Subj: ISLAND FLYER, O. N. 1131233  
Gold Coast Yachts, Inc. Hull No. GCY65WPCH202  
65' x 24' x 7' Small Passenger Catamaran (T)  
67 Passengers / Exposed Waters  
Revised Stability

Subj: ISLAND FLYER, O. N. 1131233; Revised Stability

ISLAND FLYER  
SCALE; 1/4"=1'  
AUGUST 20th, 2013

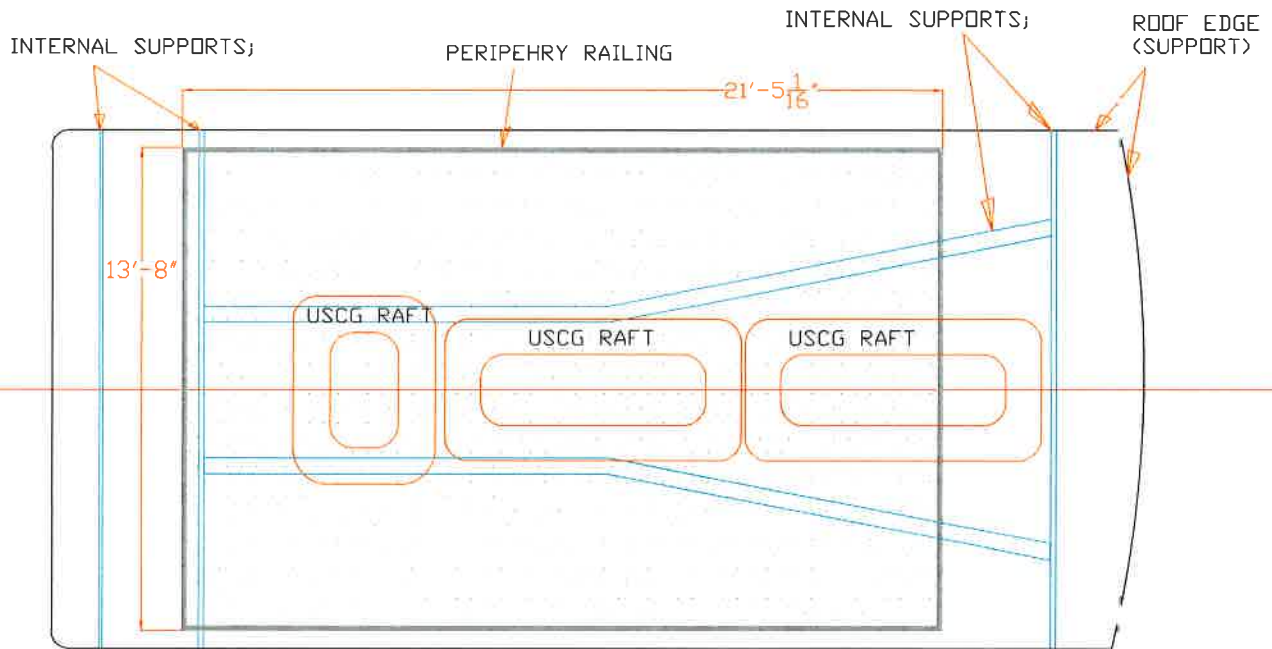
4. Due to the addition of passengers to the upper deck, new stability calculations were provided in references (b) through (e). Based on our review of the stability calculations using the revised lightship incorporating all weight changes, we concur that the subject vessel has adequate stability in all indicated conditions of loading and operation for service with up to 67 passengers, assuming an average weight of 185 pounds per person, on an Exposed Waters route.

PROPOSED ROOF AREA FOR PASSENGERS; 13'8" x 21'5".
